PA-271332

Product Advisory

Tray changes for BCM54214 & BCM54216

Tray pocket design change:

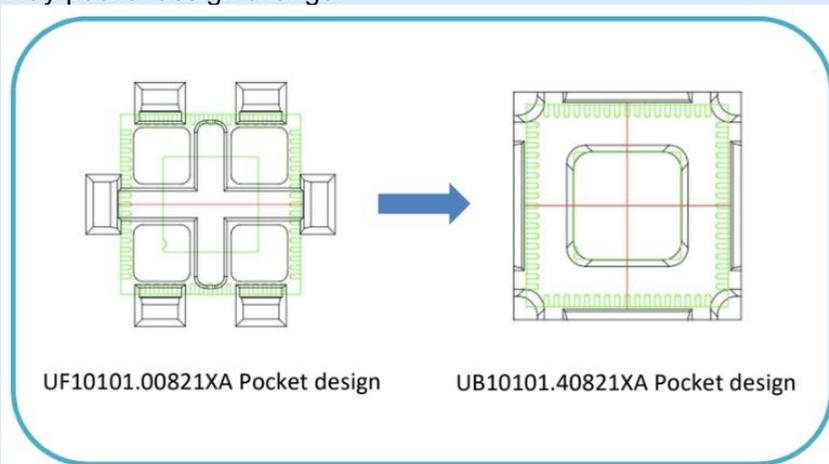
Change from Ubot UF10101.00821XA to Ubot UB10101.40821XA

Same Pitch: M=11.95, M3=16.00, M1=11.00, M2=14.65

Same Matrix: 8x21
